PROJECT STATUS	RIBA STAGE 5
CLIENT	MANCHESTER CITY COUNCIL
PROJECT	OUR TOWN HALL
DRAWING TITLE	Rooflight WCR01 Proposed Vertical Window Elevations
SIZE & SCALE	A1: Scale as Stated
DRAWING STATUS	ISSUED FOR CONSTRUCTION
JOB NUMBER	236959

DRAWING NO. **OTH-PUR-TH-RF-DWG-A- 7483** REV **02**

5
7483
PLAN OF VERTICAL GLAZING- AS PROPOSED
1:5

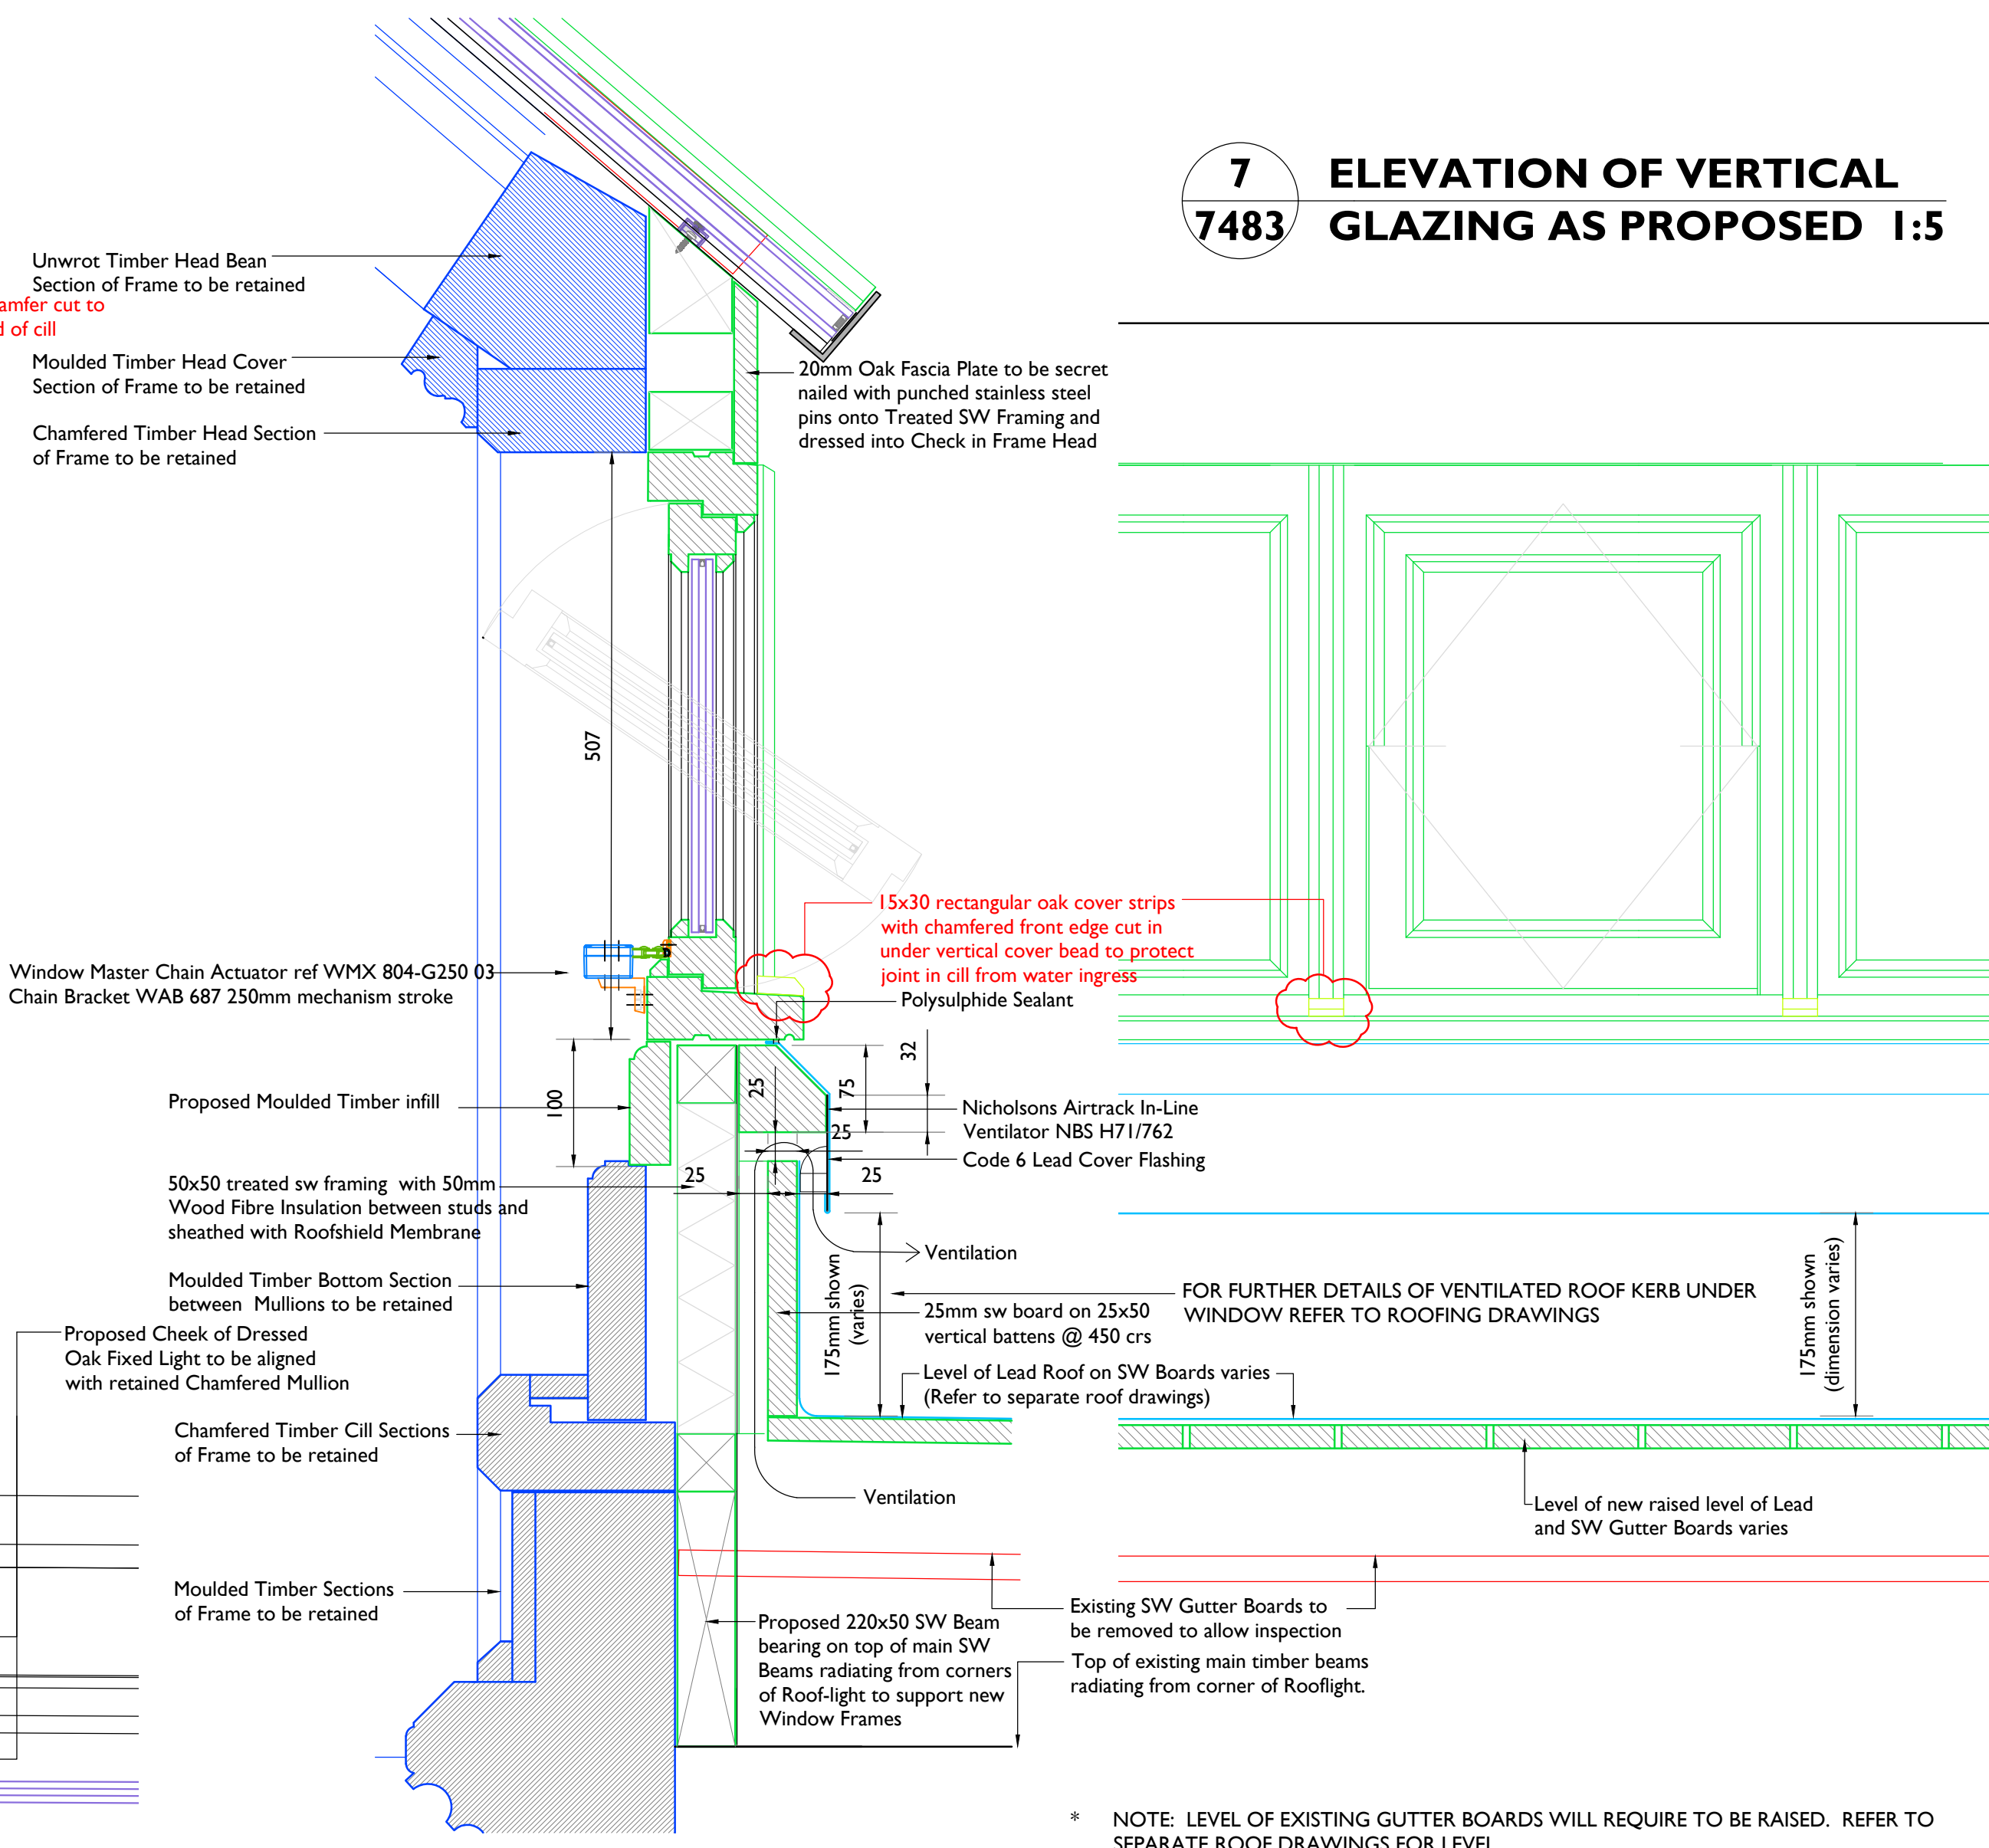
REVISION 02
As oak cill has been formed from multiple sections instead of as continuous cill, oak cover strip installed on top of cill to protect joints from water ingress
Cill end of ribbon window chamfer cut at 45°
